Remediation System Evaluation (RSE) Moss-American Superfund Site

Milwaukee, Wisconsin

**Final Report
March 2011**

Prepared by:
US Army Corps of Engineers
Environmental and Munitions Center of Expertise
and
Seattle District

Figure 2. Proposed Additional Monitoring Locations for Chemical Analysis

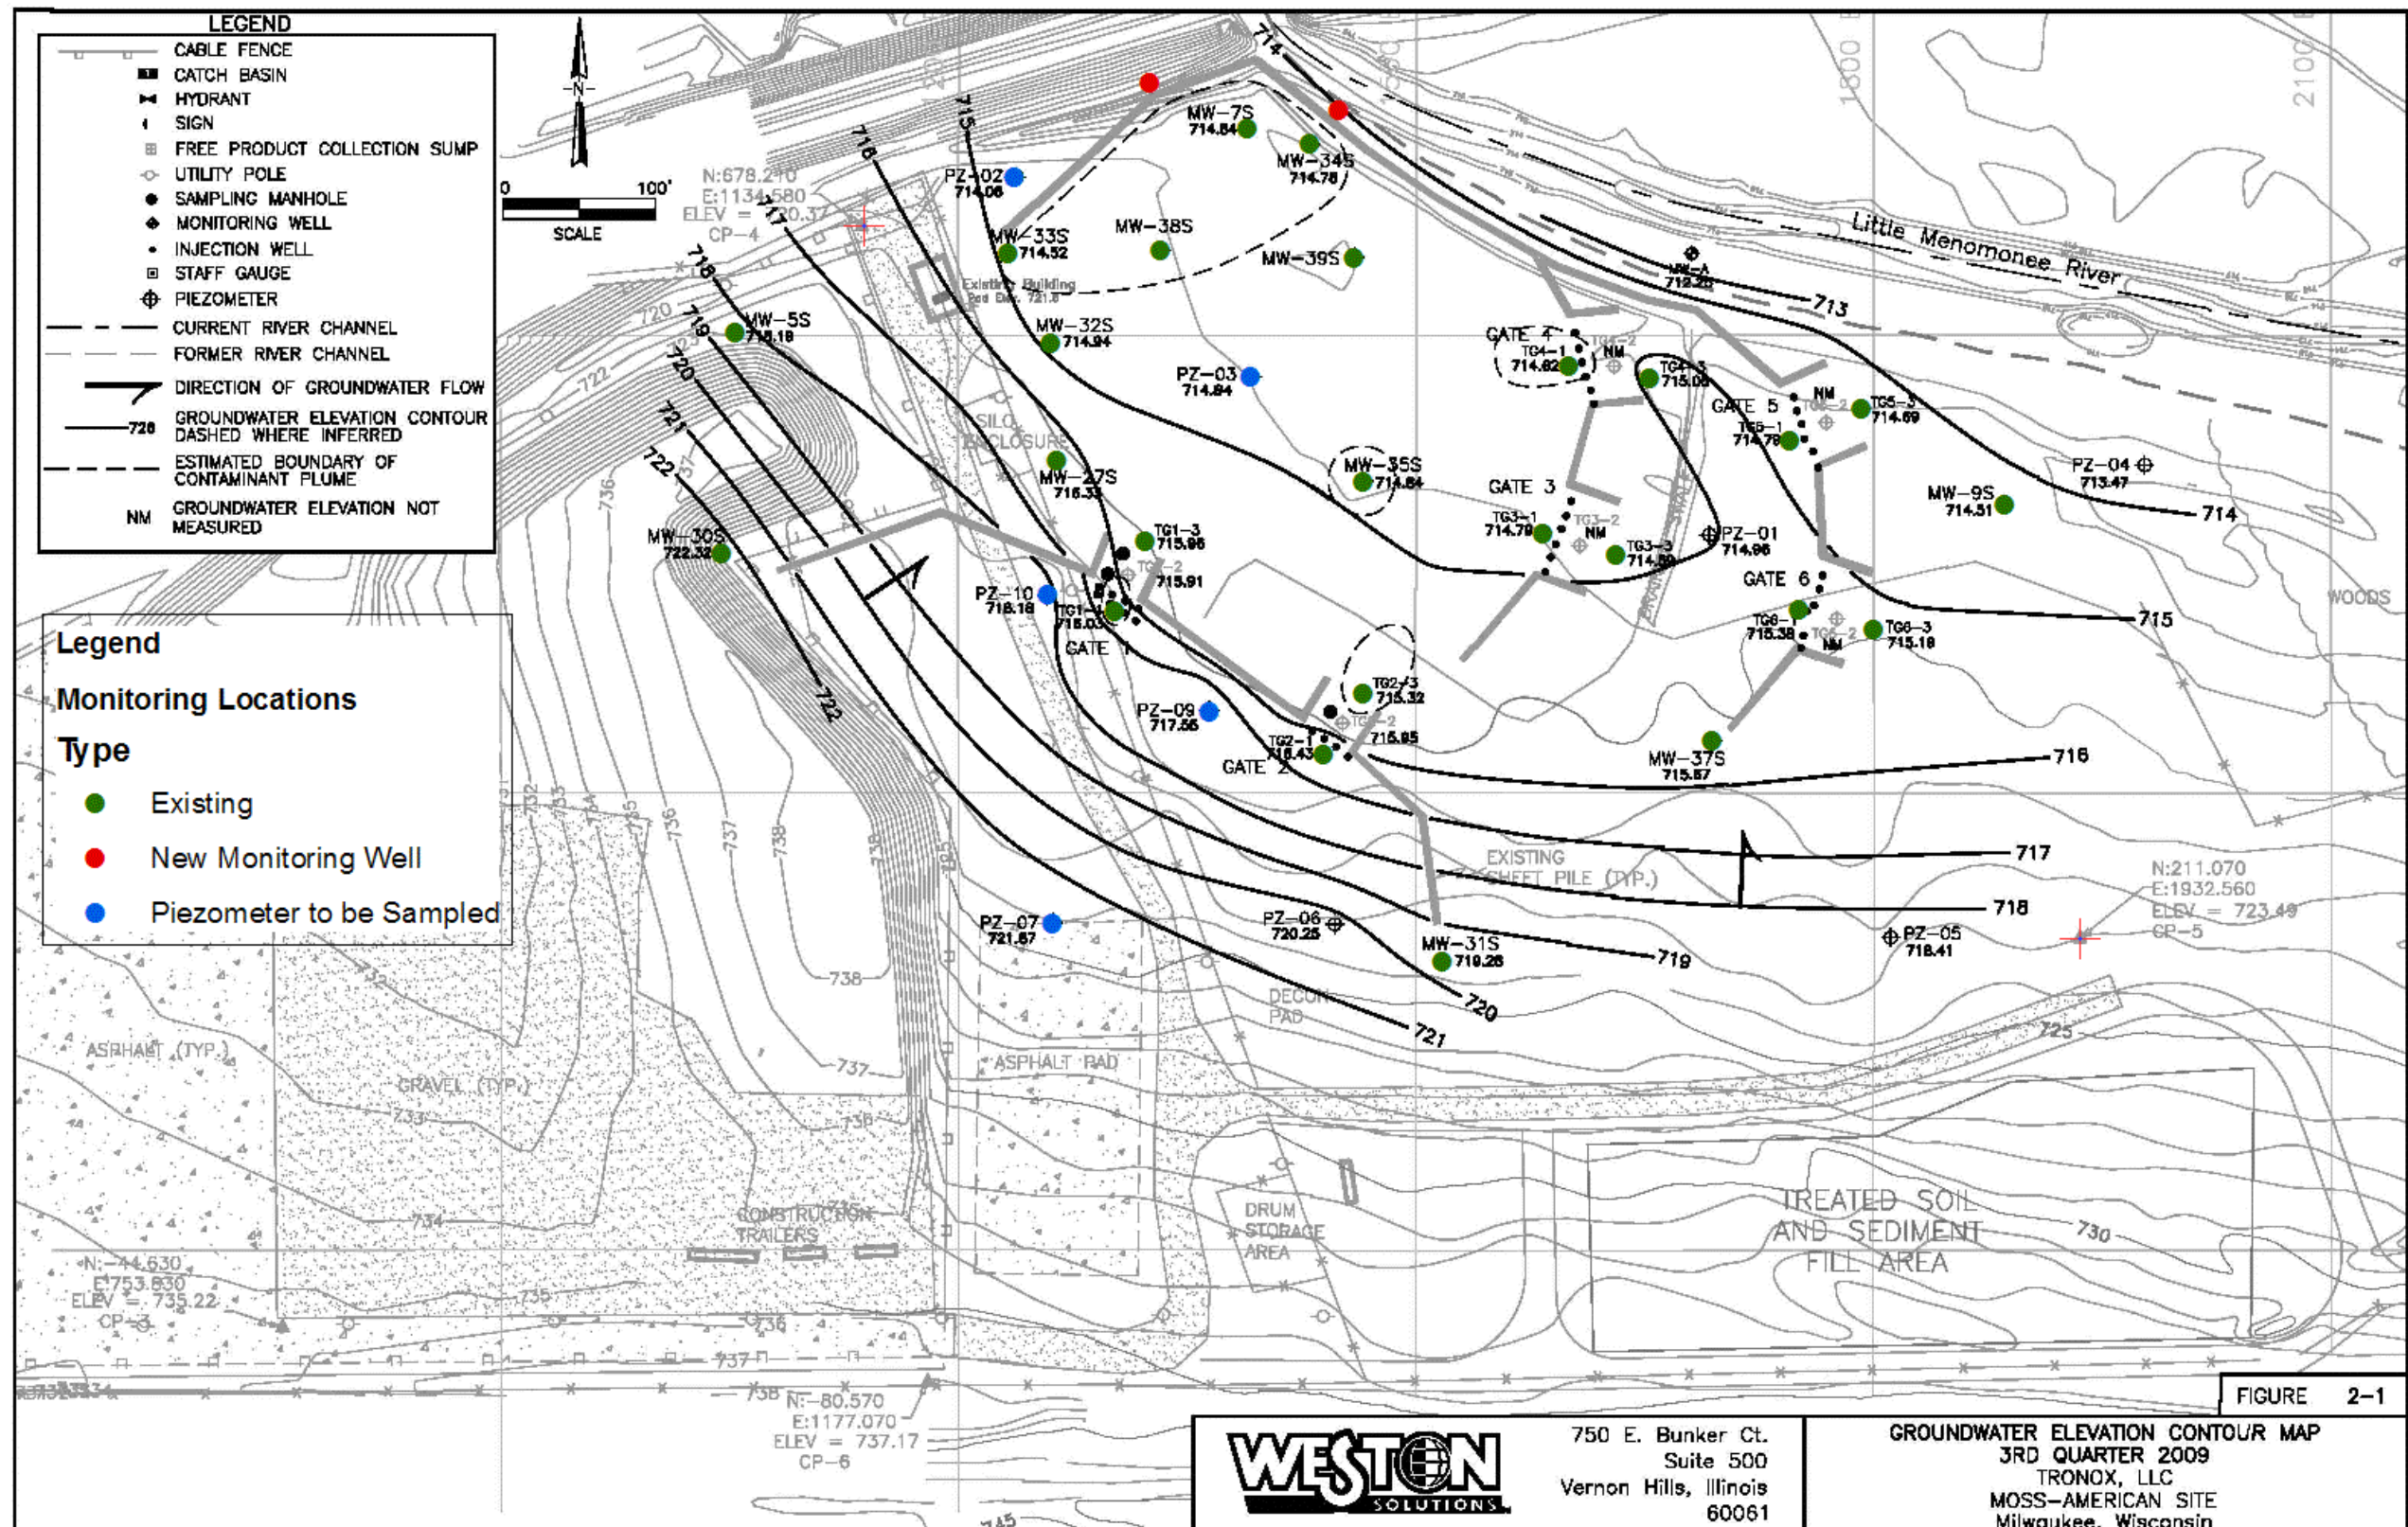
The primary areas of concern for the monitoring program are the lack of chemical data outside the sheet pile wall near MW-7S and MW-34S, where there is a possibility that contaminants could be passing through the joints or migrating around the end of the wall, and the extent of remaining contamination near TG1-1. A secondary area of concern is the extent of the dissolved-phase plume in the interior of the funnel and gate system. The following enhancements to the monitoring program are recommended (see Figure 2 for well locations):

- Install two monitoring wells outside the sheet pile wall to the north of MW-34S and to the west of MW-7S to determine if contaminants are migrating through the sheet pile wall.
- Develop and sample piezometer PZ-02 to determine if contaminants are migrating around the end of the sheet pile wall.
- Develop and sample piezometers PZ-07, -09, and -10 to determine the up-gradient extent of remaining contamination near TG1-1.
- Develop and sample piezometer PZ-03 to confirm the extent of the dissolved-phase plume in the interior of the funnel and gate system.
- Survey MW-38S and MW-39S and include water levels from these wells in groundwater flow maps.

Costs for modifying the monitoring program include **\$13,100** for the installation and development of two monitoring wells (includes oversight and reporting) and **\$5,000** for development of five existing piezometers. Prior to development of the piezometers, their construction should be verified (i.e. depth, well screen interval). Additional costs of about **\$5,900** for labor and laboratory analysis would also be accrued during each sampling event. Costing assumptions are described in Table 3. If contaminants are not detected in new monitoring locations after four sampling events, the wells/piezometers could be dropped from the program.

Figure 3. Potential NAPL Investigation Program

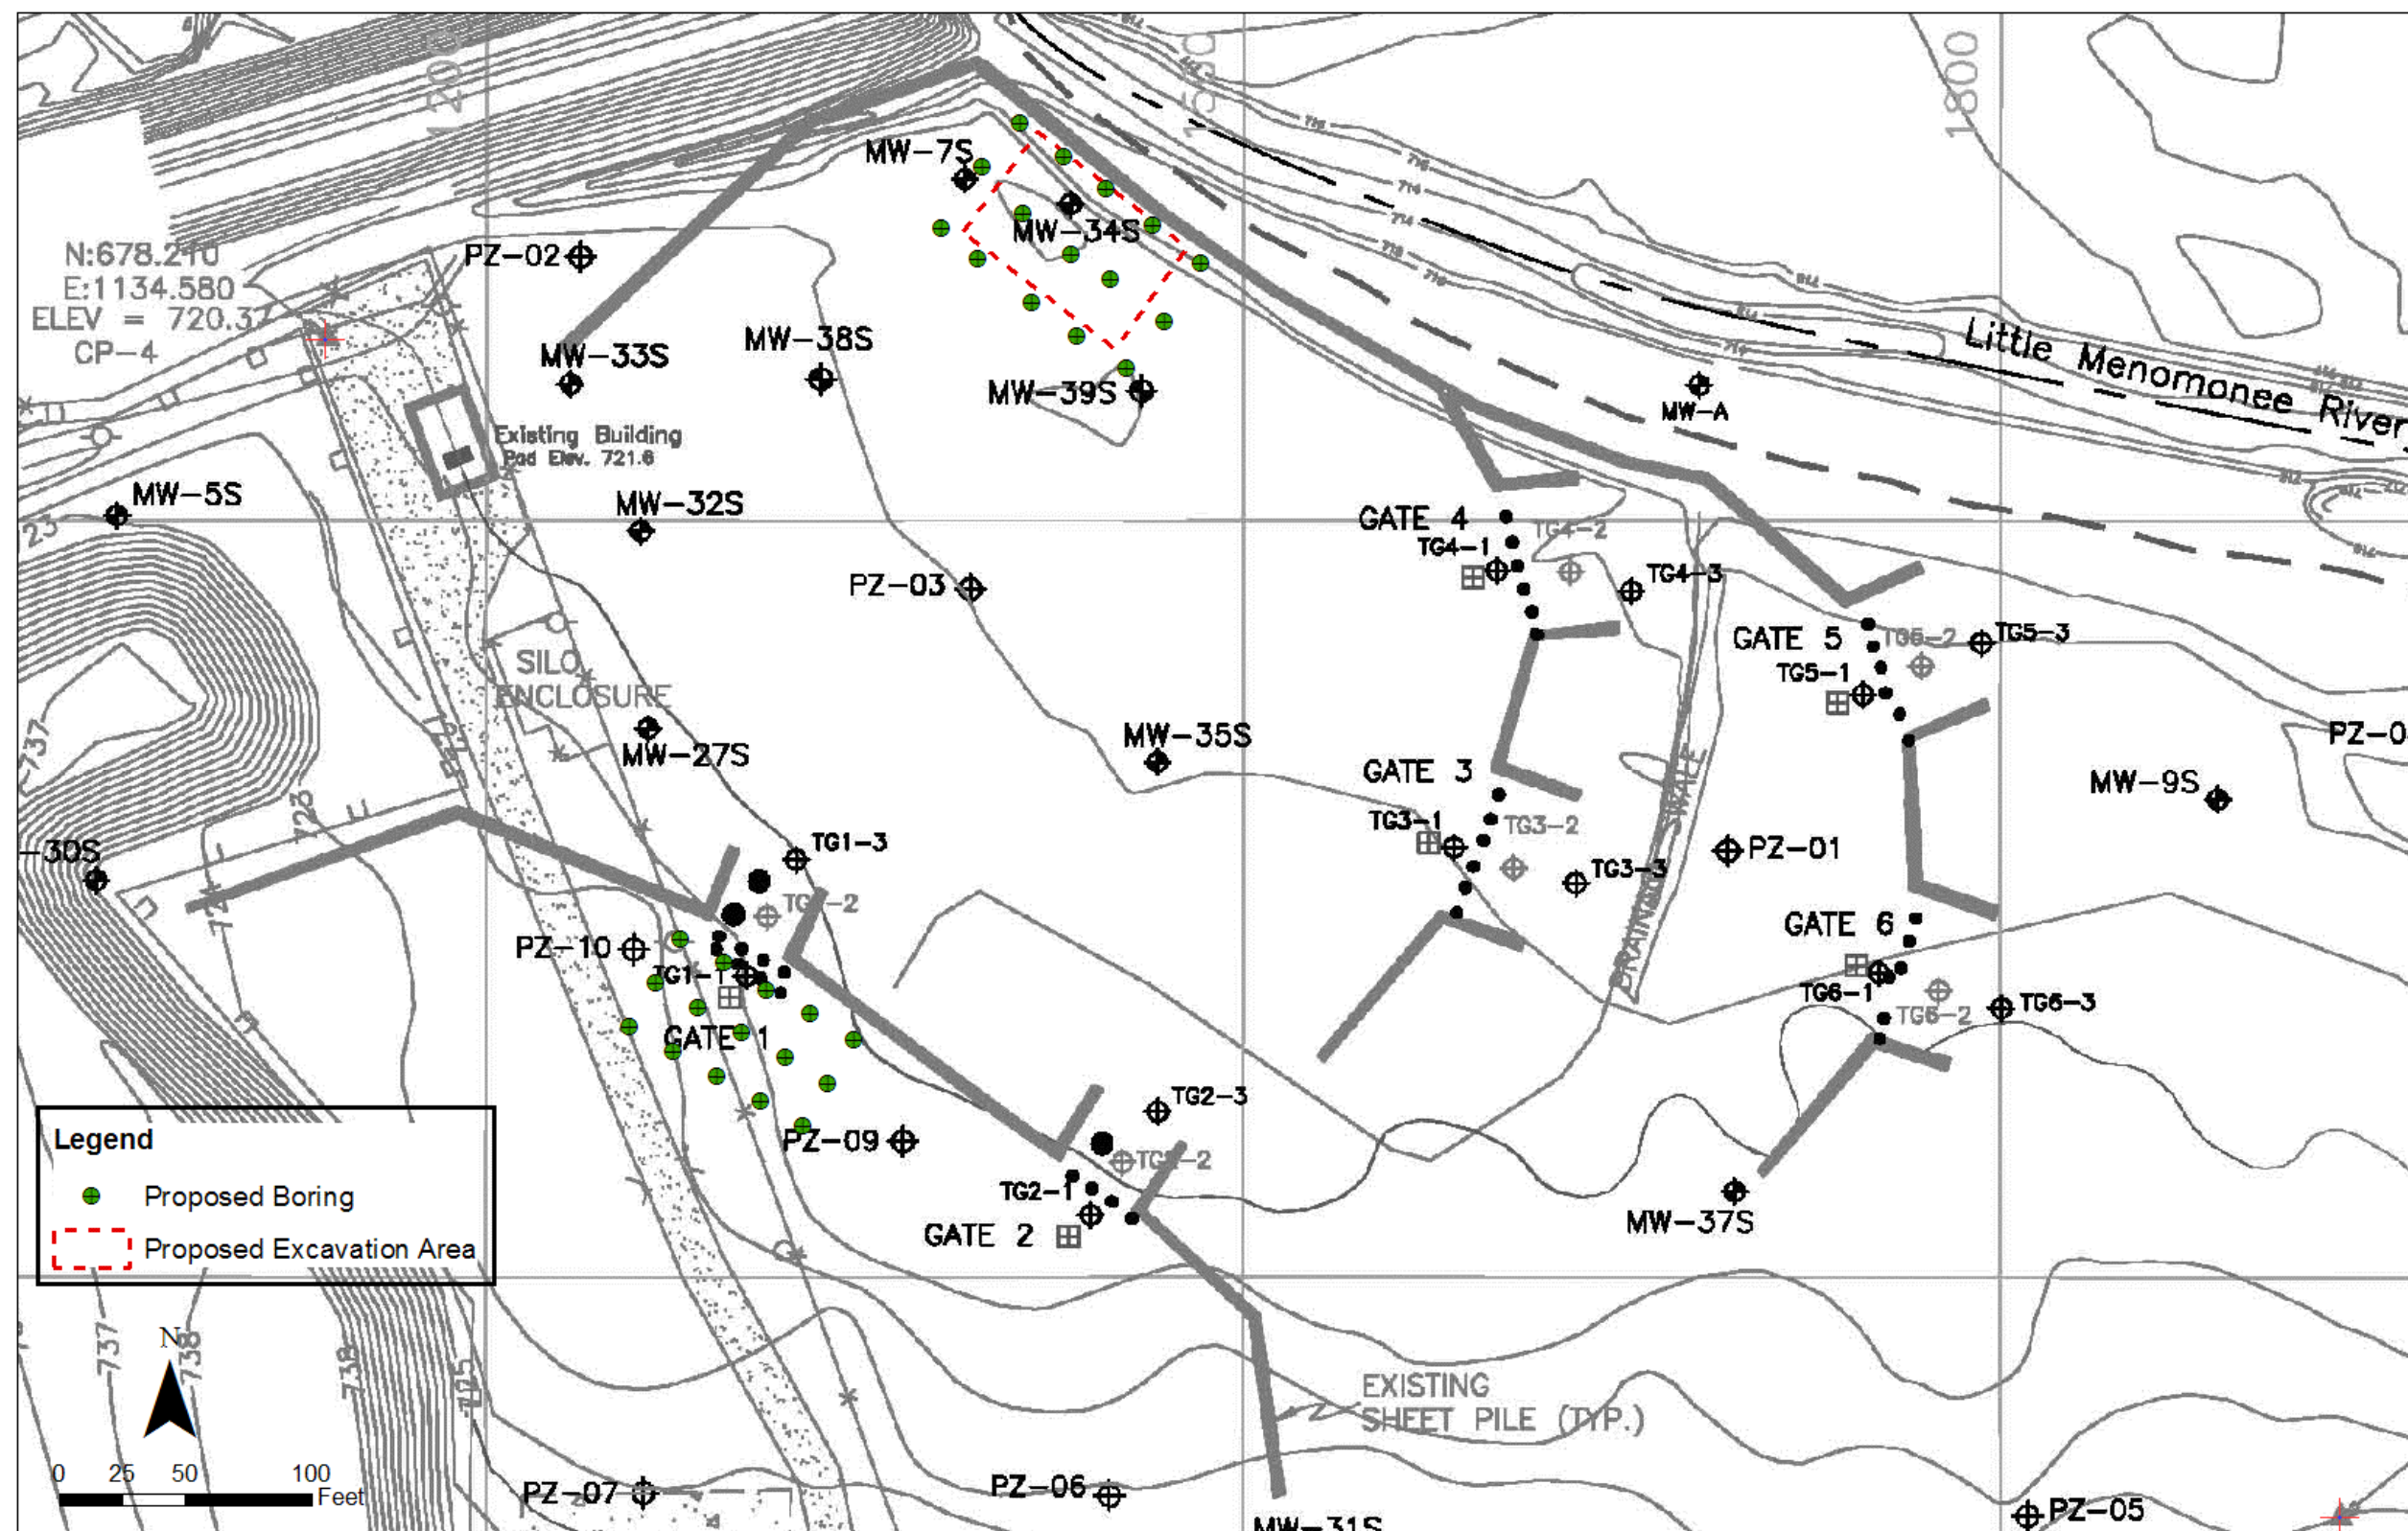
Removal of residual NAPL in areas near MW-34S and TG1-1 would eliminate this continued contaminant source to the dissolved-phase plume and shorten time to site closeout. A localized direct push soil and groundwater investigation could be implemented to spatially delineate residual NAPL contamination in these areas. NAPL is likely not uniformly distributed in site soil, which means absence of NAPL in a particular soil boring would not necessarily preclude NAPL presence in nearby soil. In order to improve NAPL delineation during the investigation, grab groundwater samples could be collected by the direct push rig during completion of soil borings. Groundwater samples with

naphthalene concentrations approaching 9,100 µg/L¹ would indicate NAPL presence in the vicinity of the soil boring. A schematic of a potential NAPL investigation program is provided on Figure 3. Locations where NAPL presence, soil concentrations or groundwater naphthalene concentrations greater than 9,100 µg/L were detected would be considered for inclusion in an excavation footprint. This investigation for each area would cost an estimated **\$36,000** based on assumptions described in Table 3.

Figure A-4. Excavation at MW-34S.

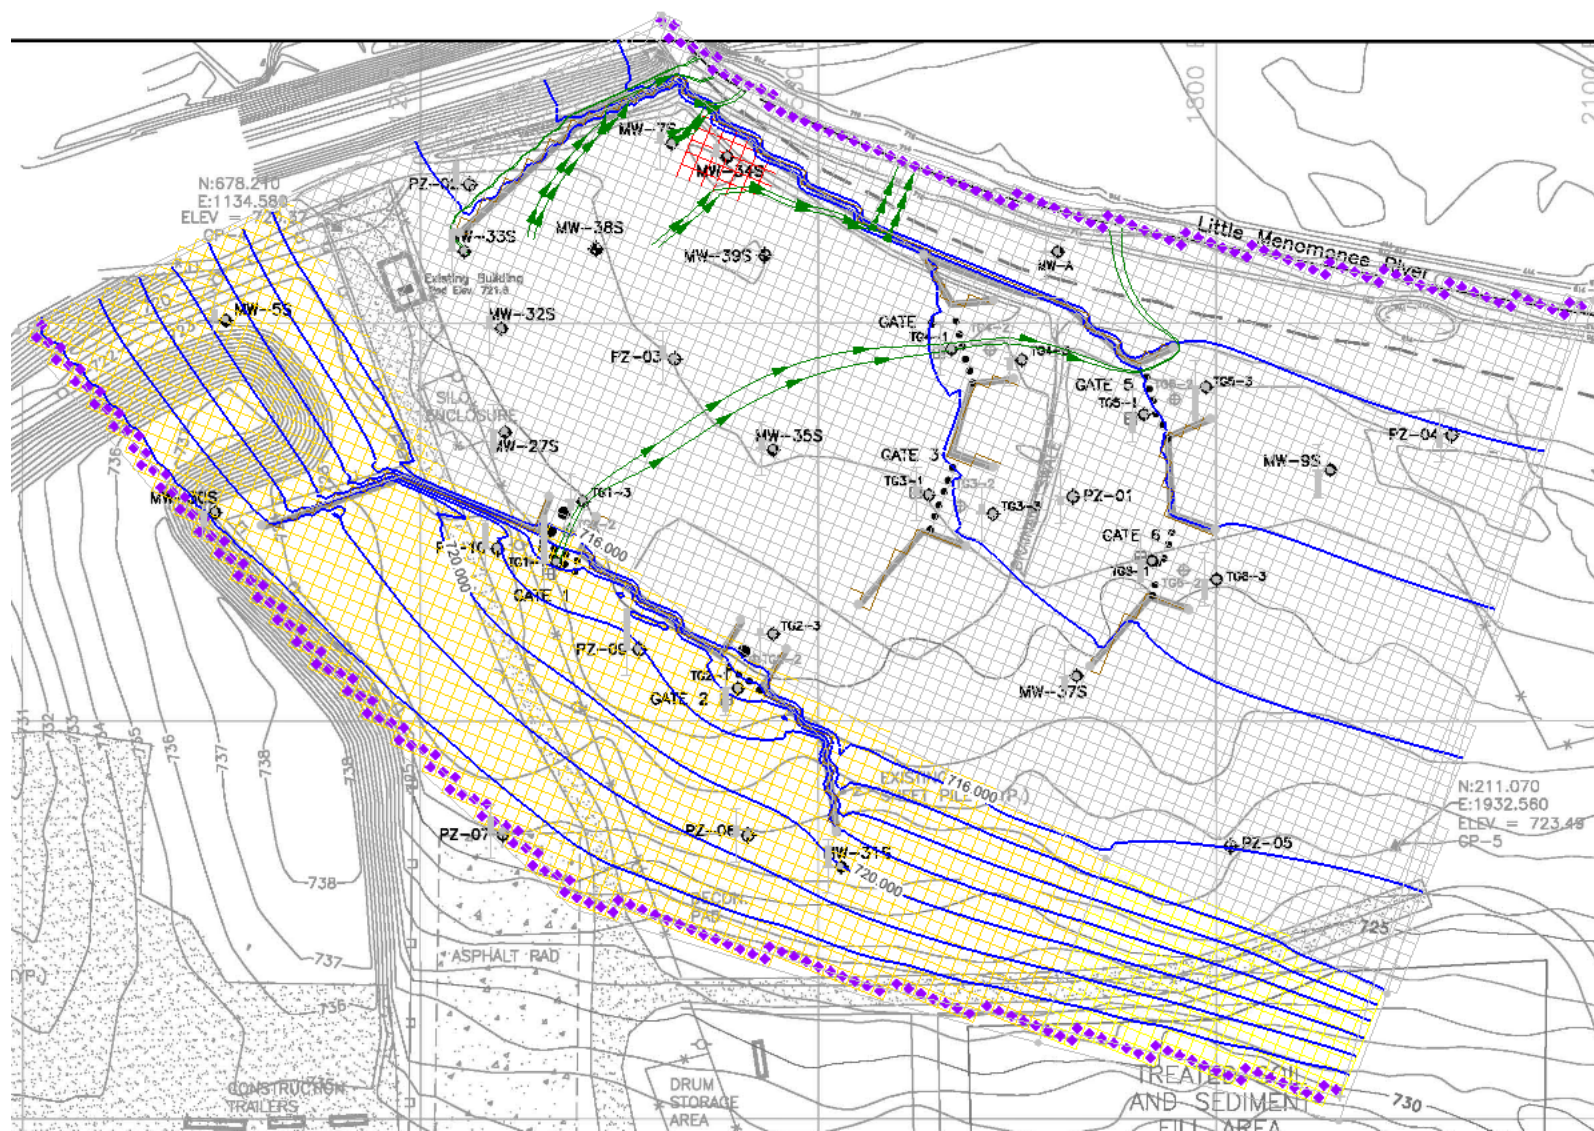
Oxygen Releasing Compound Advanced (ORC Advanced[®]) could be incorporated into the excavation backfill to enhance biodegradation of dissolved-phase contaminants in both the excavation and groundwater. Because molecular oxygen would subsequently diffuse into groundwater surrounding the ORC Advanced[®] amended backfilled area, biodegradation of dissolved-phase contaminants would be enhanced in surrounding groundwater as well. The groundwater model also showed that there would be some localized groundwater flow into the ORC backfilled area (Figure A-4).

Figure A-4 shows the groundwater elevation contours for the Excavation at MW-34S scenario. This scenario includes excavation of NAPL containing soils around MW-34S (shown in red on Figure A-4) and backfill with sand and ORC. The model shows that there will still be a stagnation area near MW-7S and MW-34S, however, the presence of the higher permeability backfill material may induce localized flow toward the treated excavation area. This scenario does not impact the potential groundwater moving around the end of the sheet pile near MW-33S.
